JOINT ARCHITECTURAL BOARD/PLAN COMMISSION AGENDA
MONDAY, MARCH 20, 2017
7:00 PM
BOARD ROOM
MUNICIPAL BUILDING, 210 COTTONWOOD AVE.

In regards to Ruckert & Mielke's Plan Review Letter to Benchmark Secured Storage dated February 17, 2017, the following notes in red are responses from Jahnke & Jahnke Associates, Inc. and Perspective Design, Inc., as referenced below.

PROPOSED SITE PLAN
FOR: LOT 2 CSM 9413
PART OF THE SW 1/4 OF SECTION 10, T7N, R18E
VILLAGE OF HARTLAND, WAUKESHA COUNTY, WI.

Sheet: T1

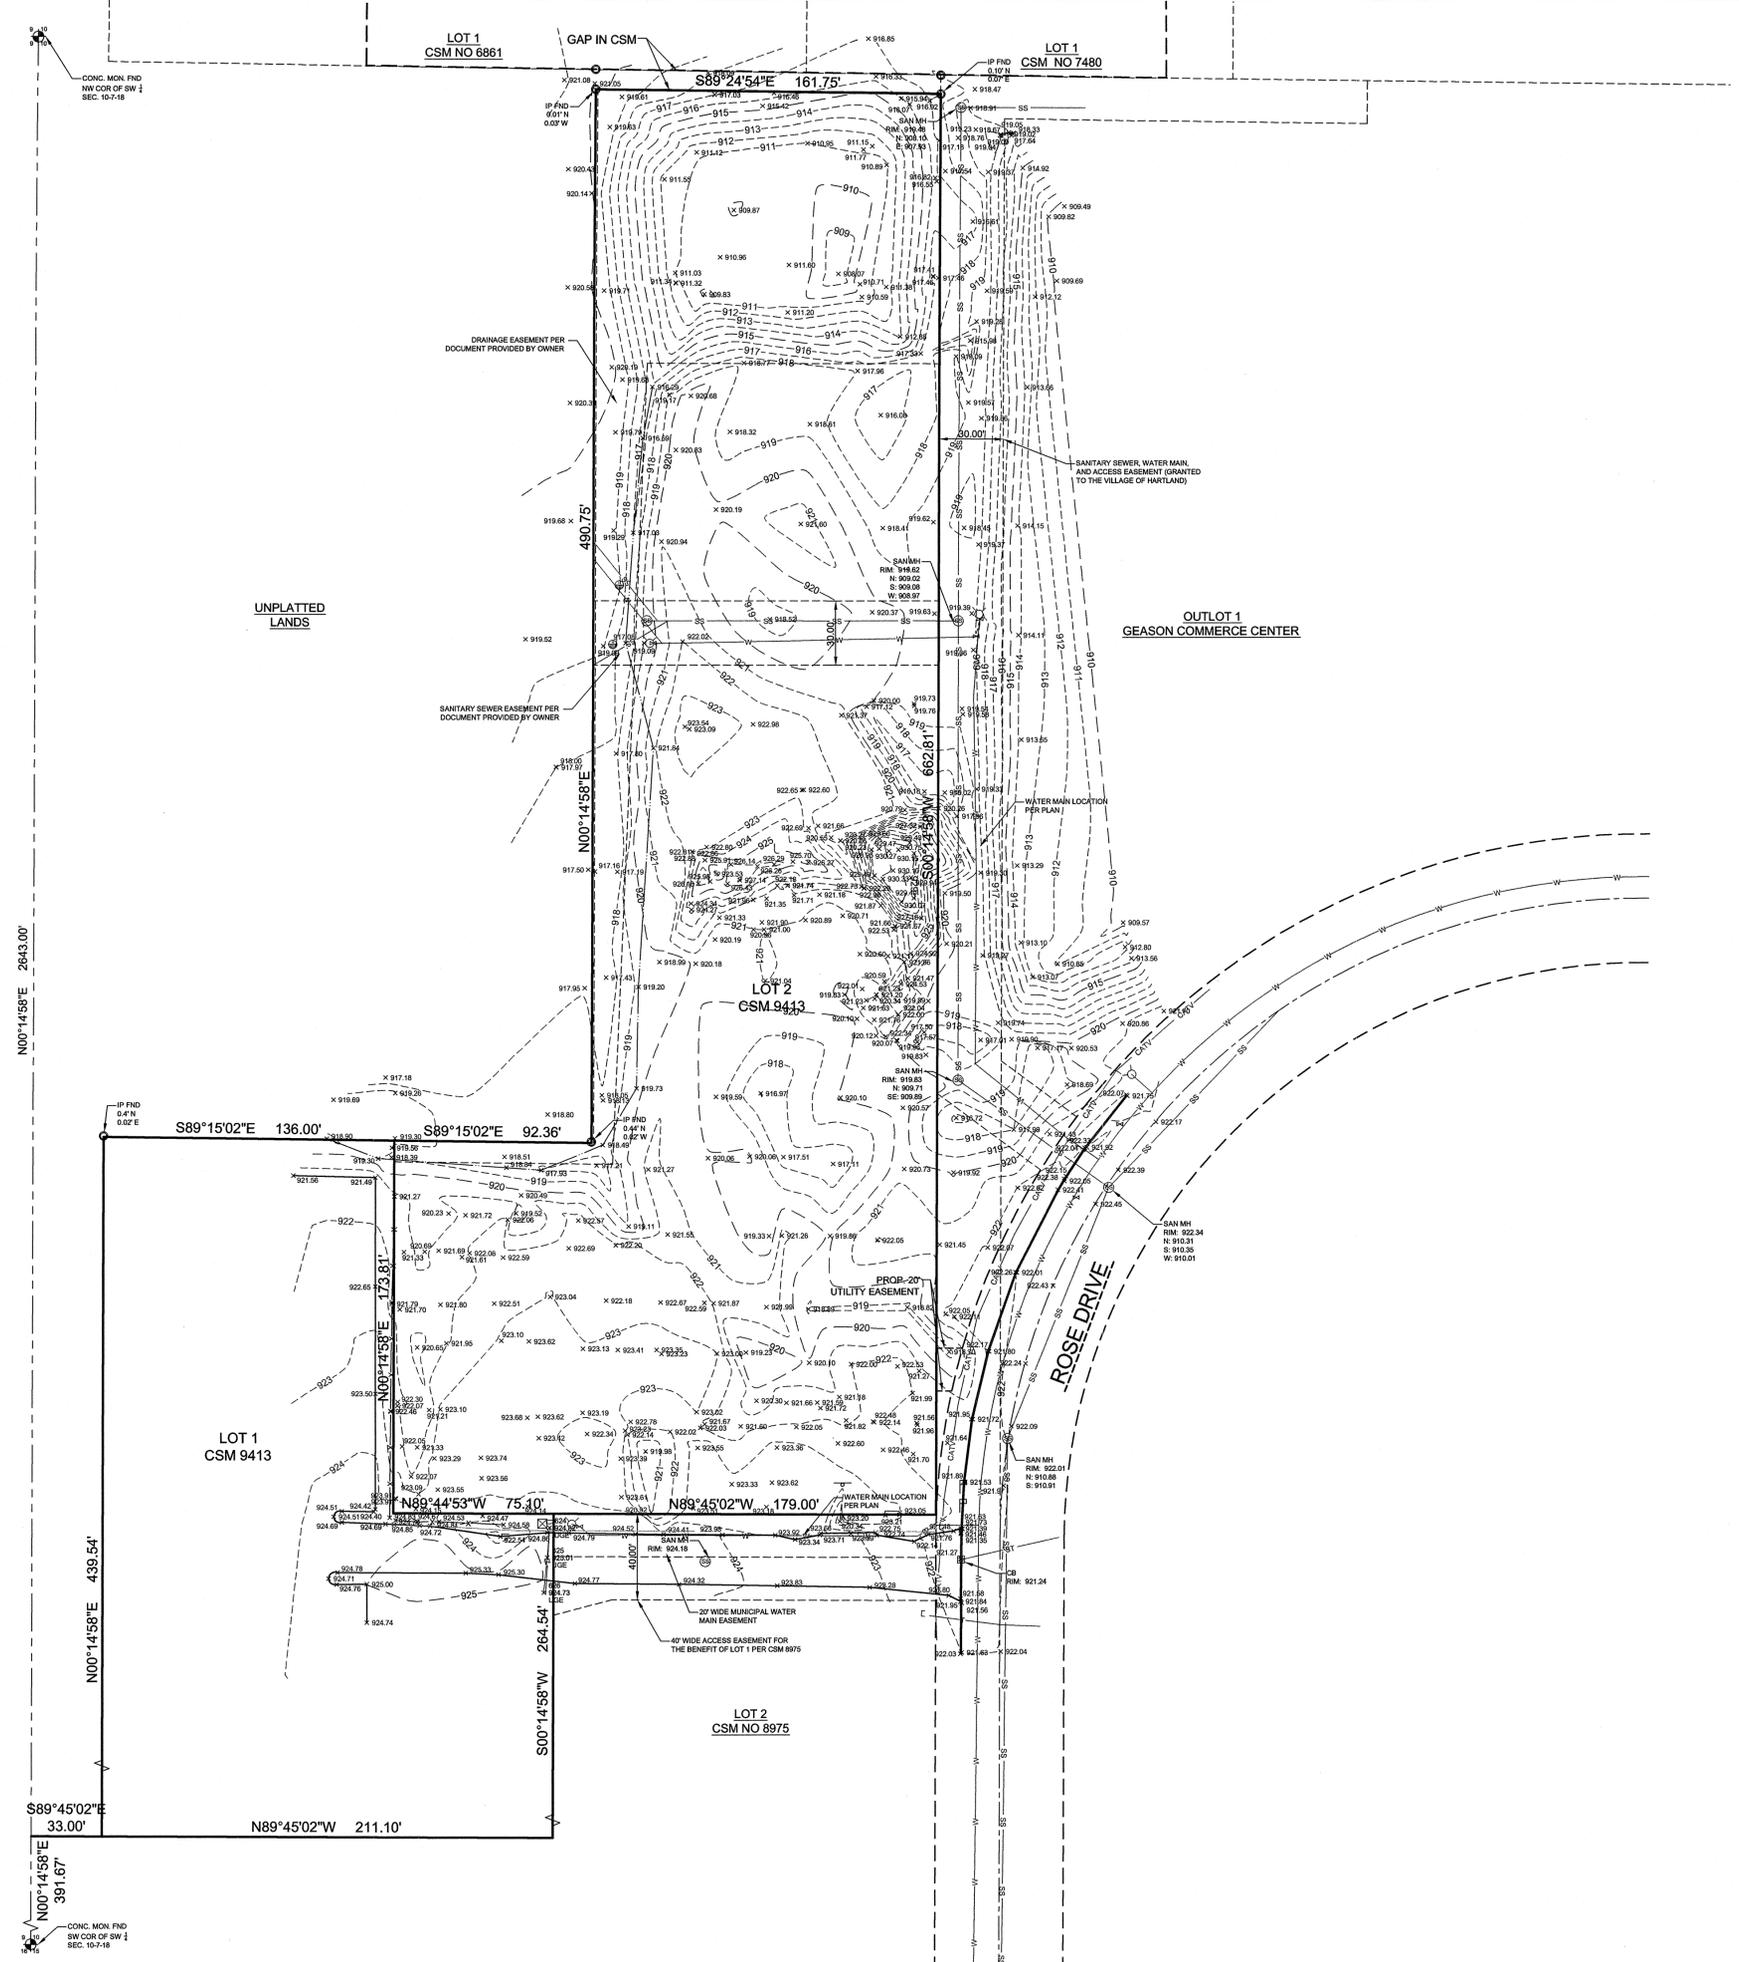
Cover Sheet (T1)

1. Provide a lighting and photometric plan sheet.
Per Perspective Design's letter dated 2.27.17, Photometric Plan Sheet has been added to the listed sheets.
2. Update Owner's zip code to 53029.
Per Perspective Design's letter dated 2.27.17, the "Owner's" zip code has been corrected.

PROPOSED SITE PLAN
FOR: LOT 2 CSM 9413
PART OF THE SW 1/4 OF SECTION 10, T7N, R18E
VILLAGE OF HARTLAND, WAUKESHA COUNTY, WI.

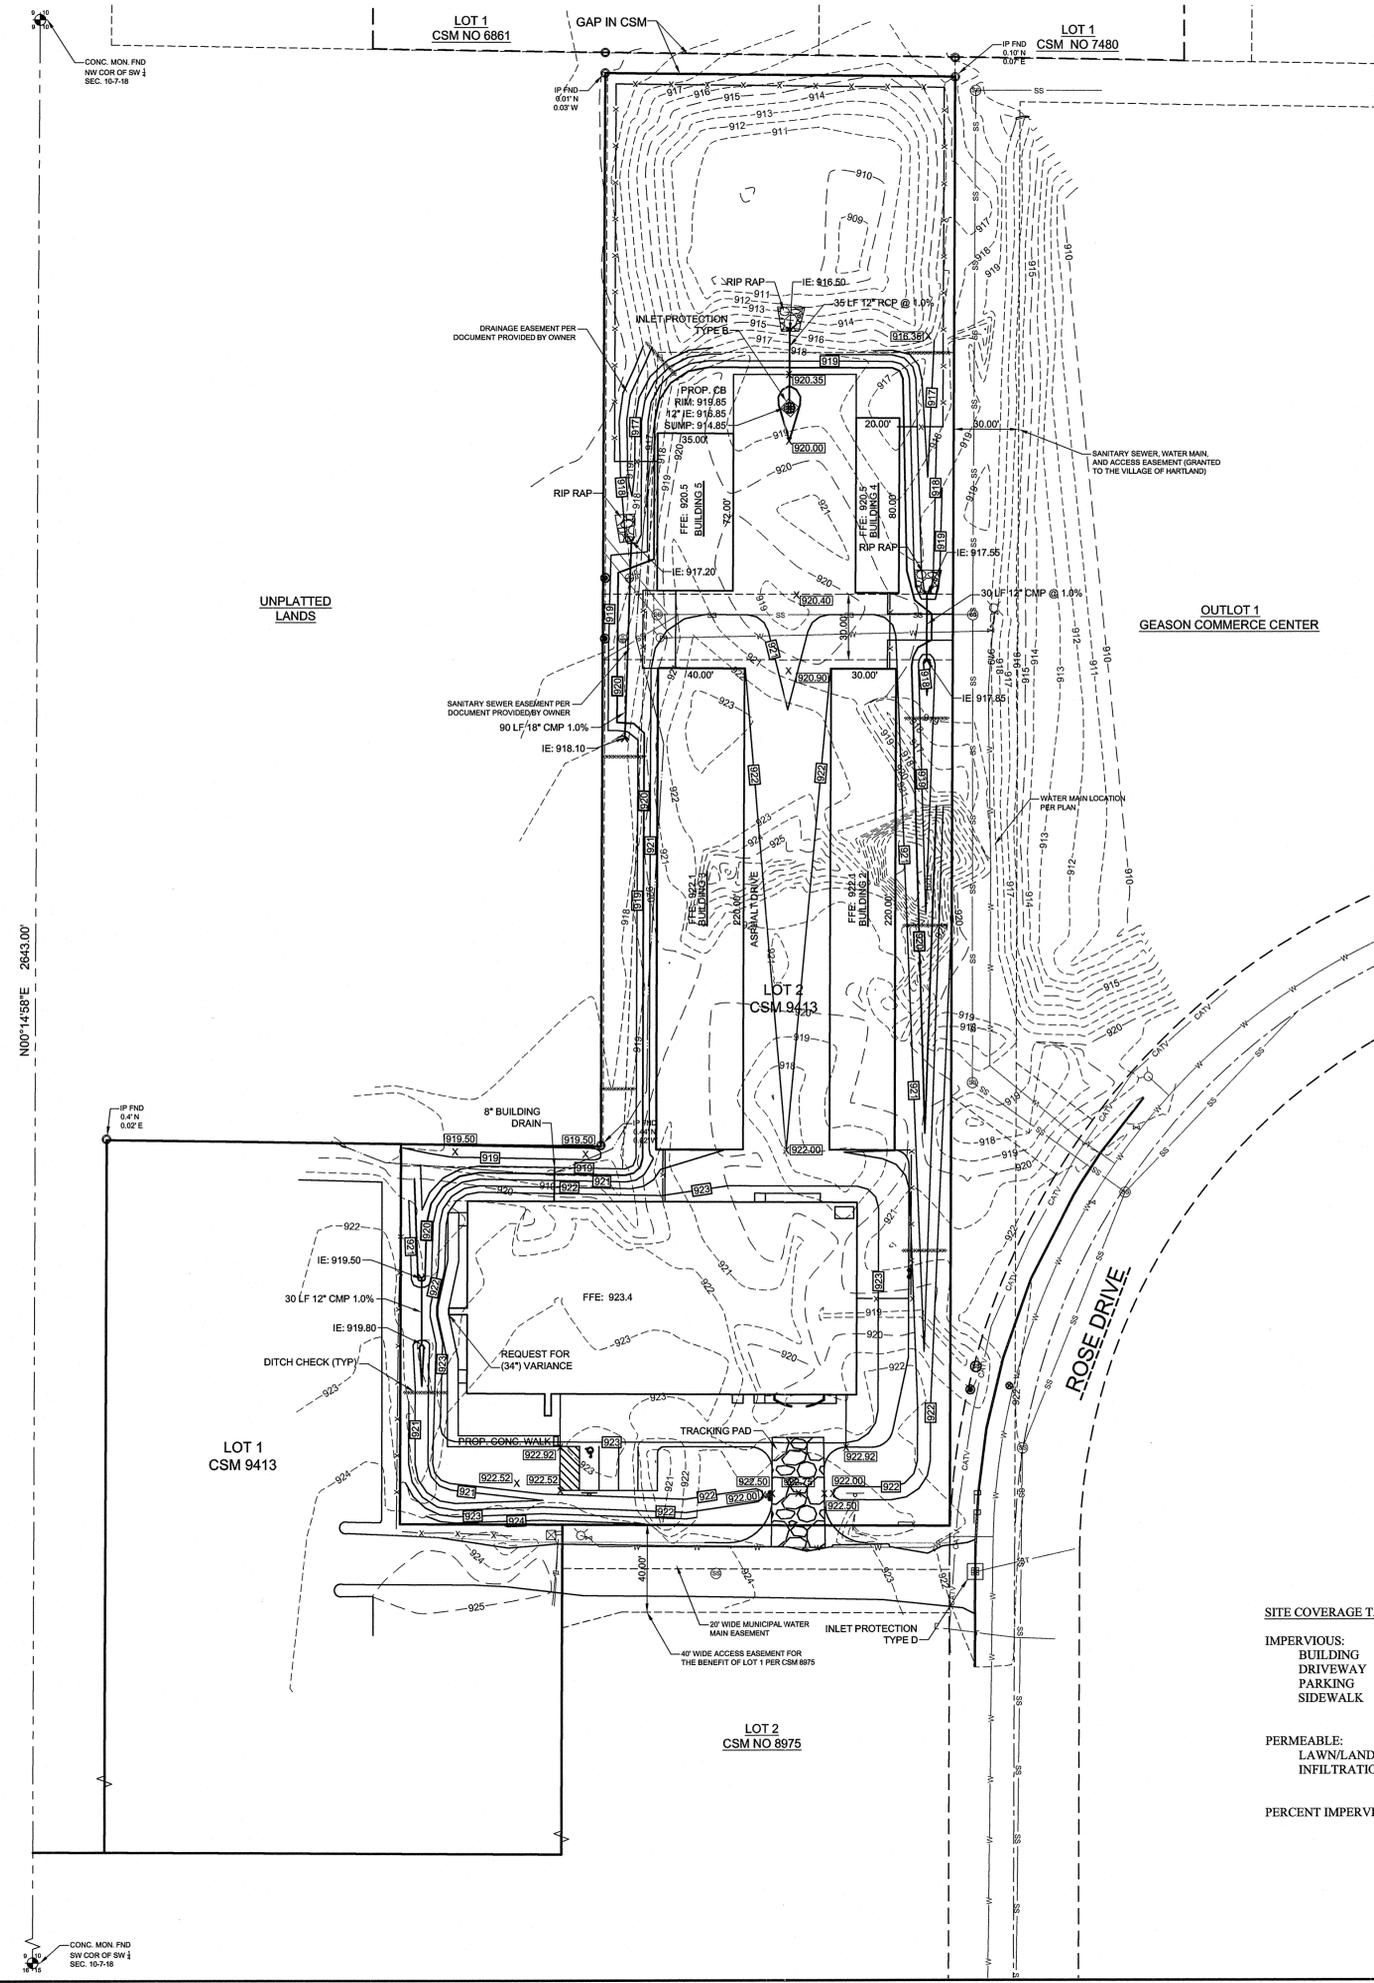
Proposed Site Plan (C1.2)

1. Architectural Site Plan and Engineering Site Plan shall be combined.
Per J&J response letter dated 3.7.17, architectural plan and civil plan has been combined.

3. Provide a minimum 12-foot wide asphalt drive for fire truck and DPW access centered within the Village's 30-foot sanitary sewer, water main and access easement and connect it to the asphalt drive in between the proposed buildings.
Per J&J response letter dated 3.7.17, 12 foot drive added.

4. Provide (2) 15' wide swing gates for Village entry into the site. Please update note and change the term "City" to "Village".
Per J&J response letter dated 3.7.17, gates upgraded to 15 foot.

5. Relocate the proposed west side fence and swing gate 8-foot to the west of the existing hydrant.
Per J&J response letter dated 3.7.17, fence relocated 8 feet.

6. Provide a fence and swing gate detail.
Per J&J response letter dated 3.7.17, fencing details provided.
7. Provide a No Parking sign in between both sets of buildings in the easements.
Per J&J response letter dated 3.7.17, no parking signs provided.

8. Show existing curb boxes and sanitary laterals for the adjacent northwest property
Per J&J response letter dated 3.7.17, water services and sewer laterals shown.

9. Provide a site coverage table listing the permeable and impervious totals for the site.
Per J&J response letter dated 3.7.17, site coverage table provided.

10. Include parking calculations.
Please reference attached letter from Doug Hafemann addressing parking and loading.
11. Highlight the paved areas and show the paving limits along the north side of the site.
Per J&J response letter dated 3.7.17, paved areas delineated.

12. Provide a detectable warning field to ensure ADA Compliance for parking lots.
Per J&J response letter dated 3.7.17, detectable warning field added.
13. Show details of construction.
Per J&J response letter dated 3.7.17, details added.

14. Include a handicap sign and post.
Per J&J response letter dated 3.7.17, handicap sign and post added.
15. Show dimension for parking stalls, driving aisle, sidewalk width and radii.
Per J&J response letter dated 3.7.17, dimensions added.
16. The dumpsters are shown within the secured area of the site. How will the garbage be pick up?
Provide details for trash enclosure.
-Per J&J response letter dated 3.7.17, two cy dumpsters will be in carp port. Shown.
-Please reference attached letter from Doug Hafemann addressing dumpster placement and garbage pick up.
17. Investigate turning angles of 33' fire truck, drainage, landscaping, etc., as well as illustration of fire truck turning radius provided by Paul Jenswold.
Please see email dated 3.7.17 to David Cox from Doug Hafemann.

GRADING AND EROSION CONTROL PLAN

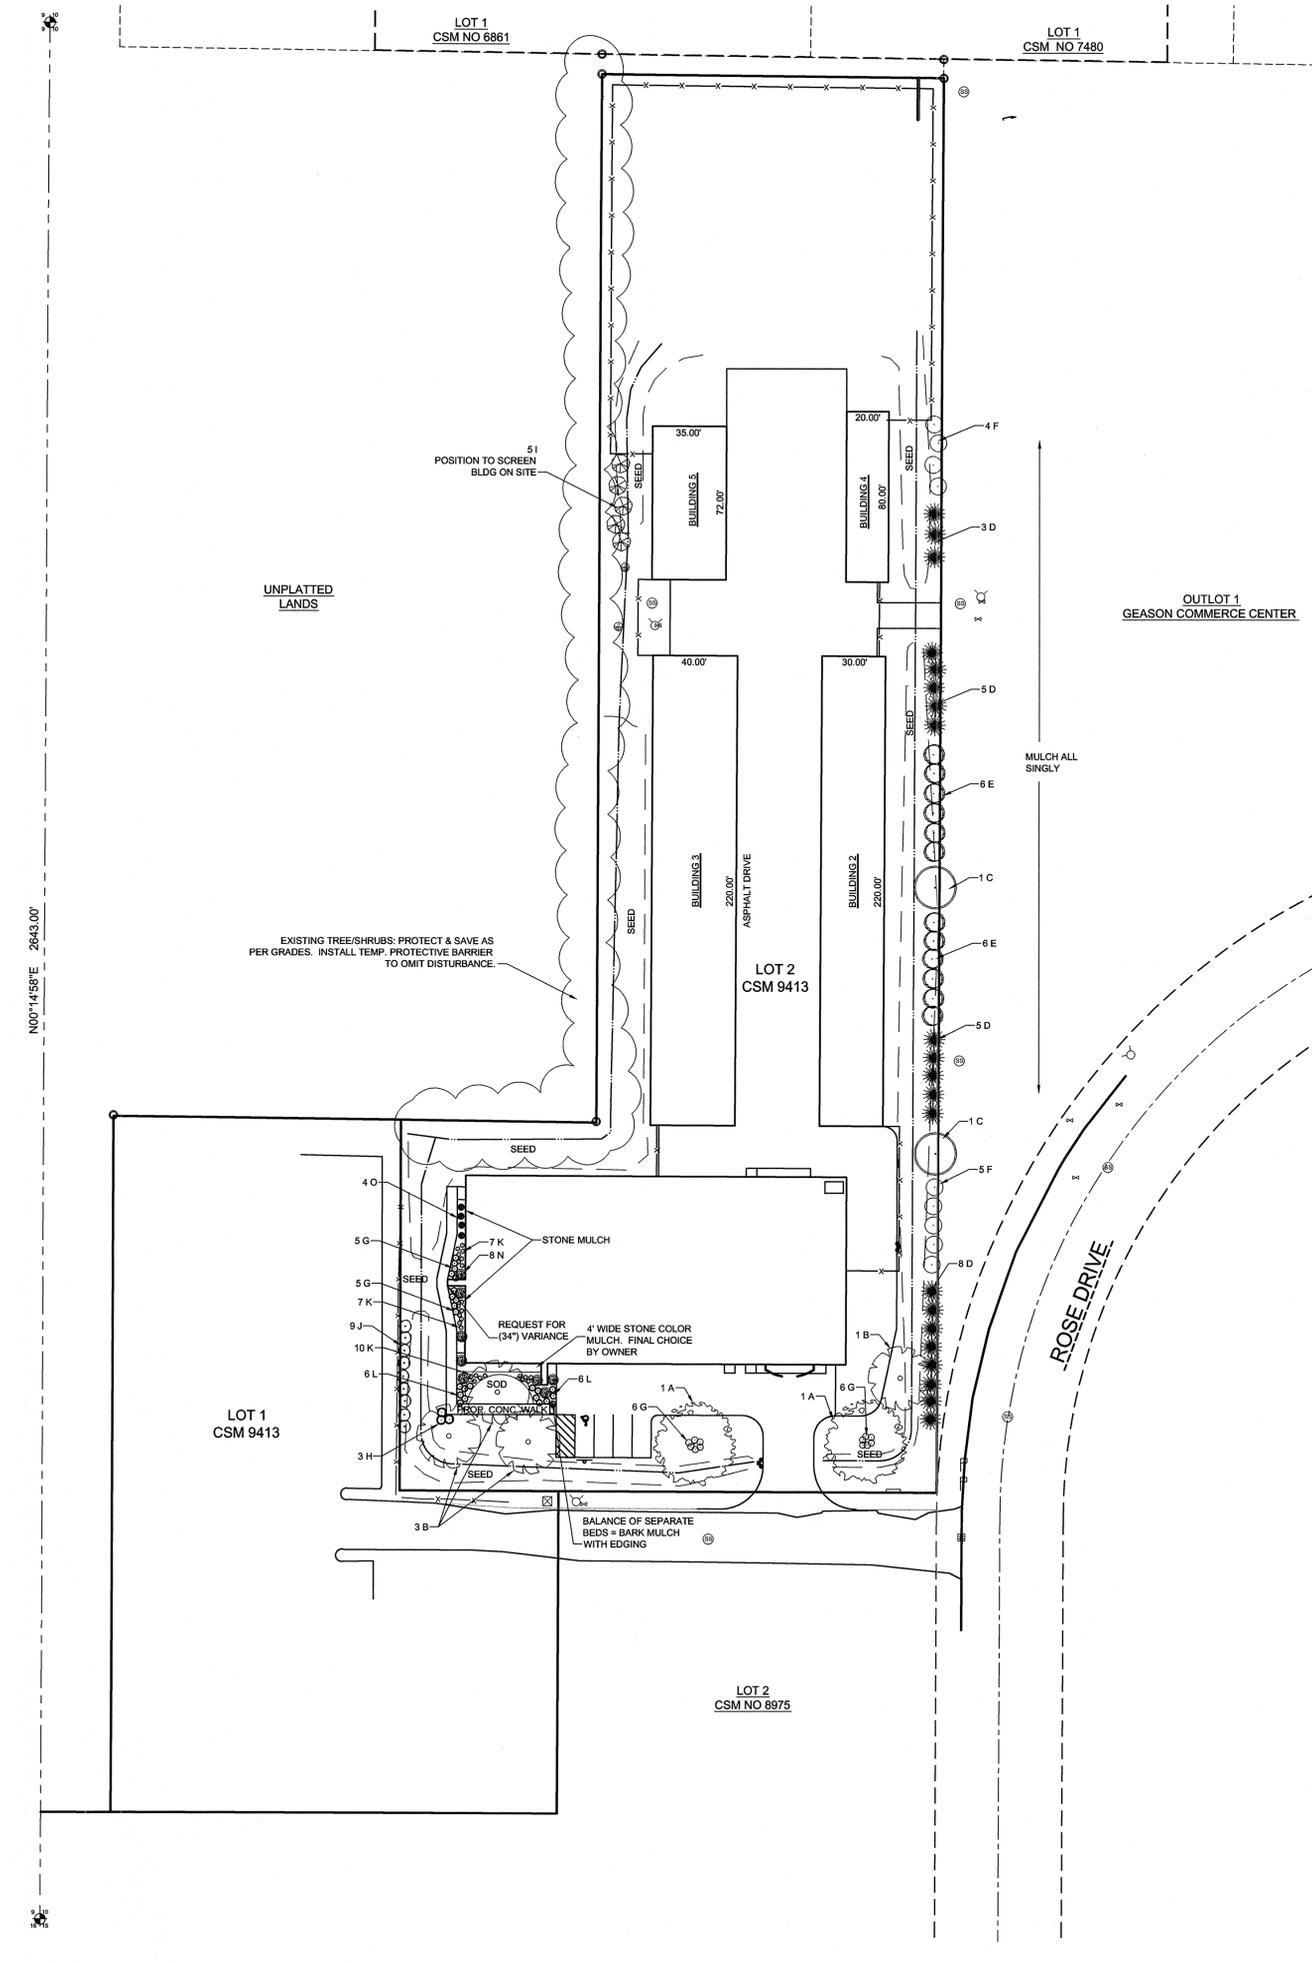
Grading and Erosion Control Plan (C1.3)

1. Provide Type D inlet protection for the inlets in Rose Drive.
Per J&J response letter dated 3.7.17, type D inlet protection added.
2. Provide proposed grades and contours for the 12-foot wide asphalt access drive.
Per J&J response letter dated 3.7.17, grading shown for 12 foot access drive.

3. Further define the proposed swale along the northwest corner of proposed building #1 to ensure that all runoff remains onsite and not onto the adjacent property.
Per J&J response letter dated 3.7.17, swale has been further defined to ensure that the residential property is not affected.

4. Install insulation for freeze protection between the existing water main/services and proposed cross culvert.
Per J&J response letter dated 3.7.17, insulation under culverts and over water main added.

5. Provide the proposed size for the CMP cross culverts.
Per J&J response letter dated 3.7.17, culvert sizes shown.
6. Show locations of roof drainage discharge.
Per J&J response letter dated 3.7.17, roof drainage location shown.

7. Include the following notes to the Construction Sequence: "Install inlet protection, silt fence and all other erosion control measures prior to any land disturbing activities, as shown in plans." and "Adjust and maintain erosion control measures as necessary as construction operations progress."
Per J&J response letter dated 3.7.17, note added.

8. Include the following note to the Construction Notes: "Contractor shall sweep Villages roadways and any affected private driveway adjacent to the project area at the end of each work day, or as directed by the Village or Engineer to maintain clean and safe surfaces."
Per J&J response letter dated 3.7.17, note added.

9. Show erosion control details for construction.
Per J&J response letter dated 3.7.17, details added.
10. Currently, there are existing fallen trees within the embankment of the existing storm facility.
Provide notation to remove these existing fallen trees.
Per J&J response letter dated 3.7.17, note added.
11. Update fence note to provide for (2) 15' wide swing gates for Village entry into the site. Please update note and change the term "City" to "Village"
Per J&J response letter dated 3.7.17, gate upgraded to 15 foot.
